ONS-2013-015

Subject: Duke Energy Carolinas, LLC
Oconee Nuclear Station, Units 1, 2, and 3
Docket Nos. 50-269,-270,-287
Emergency Plan, Volume A, Revision 2013-01

VOLUME A
REVISION 2013-01
NOVEMBER 2013

**SUBJECT: Oconee Nuclear Site Emergency Plan
Volume A, Revision 2013-01**

FIGURE J-5
Oconee Nuclear Site
Building Layout

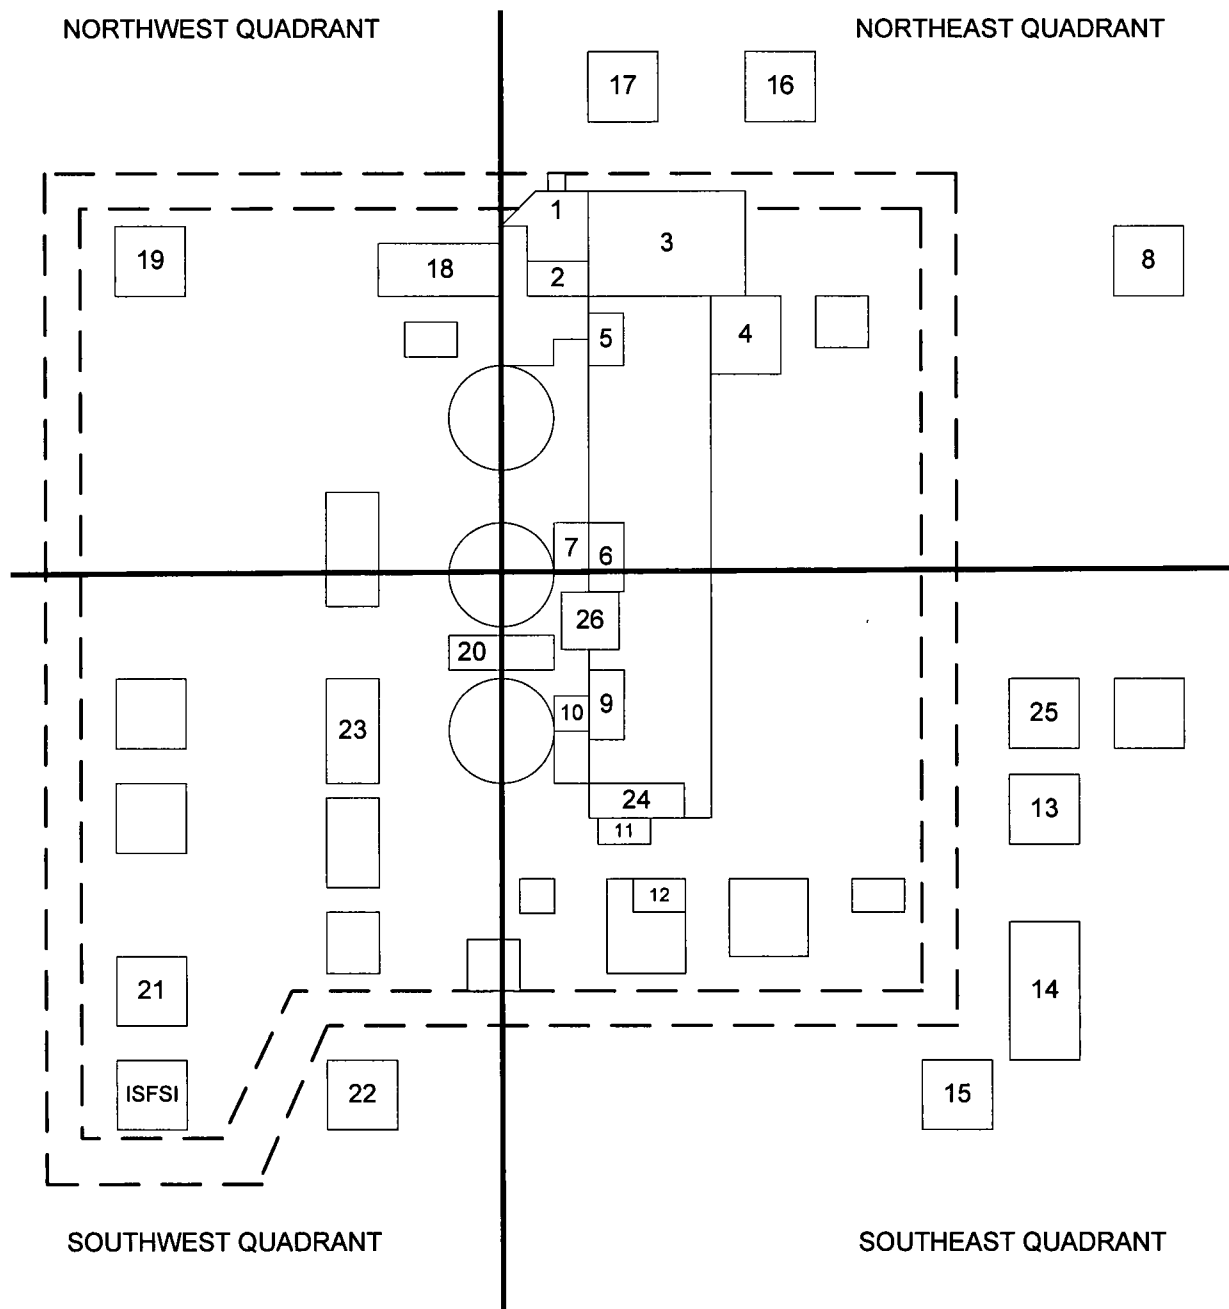
Oconee Emergency Plan revision 2013-01, New Evacuation Time Estimate				
Change #	Document Number / Page / Section	Current Wording	Proposed Wording	Reason for Change
1	ONS E Plan / Page J1 / J.1	Site Accountability locations, Figure J-7	Site Accountability locations, Figure J-5	Editorial
2	ONS E Plan / Page J2 / J.3	(Figures J-5, J-6)	(Figures J-3, J-4)	Editorial
3	ONS E Plan / Page J4 / J.8	A description of the methods and assumptions used in developing the evacuation times is included in the 2002 study of the Oconee Nuclear Site prepared by Duke Energy Environmental Health And Safety Services. These estimates will be considered in evaluating protective action recommendations from the Technical Support Center or the Emergency Operations Facility. A copy of the study is available in the Technical Support Center and the Emergency Operations Facility.	A description of the methods and assumptions used in developing the analysis of evacuation time estimates is included in the current Evacuation Time Estimate study for the Oconee Nuclear Site. (ONS-ETE-12142012, Rev. 000; ONS EVACUATION TIME ESTIMATES (ETE) DATED 12/14/2012.) The Evacuation Time Estimates will be considered in evaluating protective action recommendations from the Technical Support Center or the Emergency Operations Facility. A copy of the most recent study is available in the Technical Support Center and the Emergency Operations Facility.	Incorporate newly revised ETE's into the existing Oconee Nuclear Station E Plan.
